**Development Application DA2021/1341
Issues response/ Supplementary Statement of Environmental Effects
Amended plans and clause 4.6 variation request – Height of buildings
Demolition and construction of multi dwelling housing
3 Brookvale Avenue, Brookvale**

**Amended clause 4.6 variation request – Height of buildings
Proposed multi dwelling housing
3 Brookvale Avenue, Brookvale**

Figure 1 – Eastern elevation plan extract showing minor 255mm breaches of the front and rear pavilion roof forms

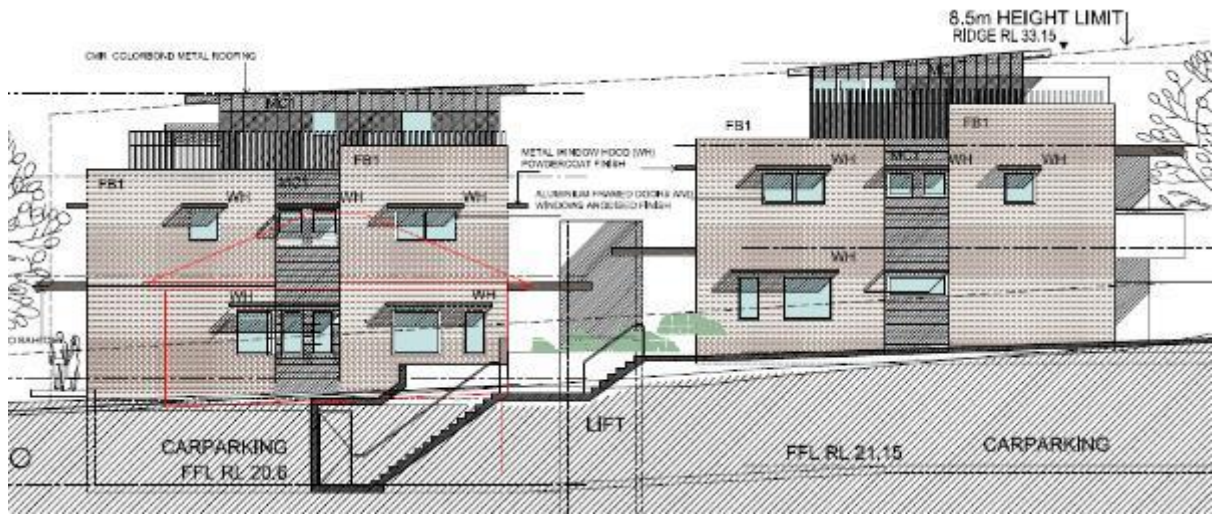
It has been determined that the front and rear pavilion roof forms breach the height standard by a maximum of 255mm (3%) as depicted in Figures 1 and 2 below.

I note that the areas of non-compliance are limited to the small areas of roof form.
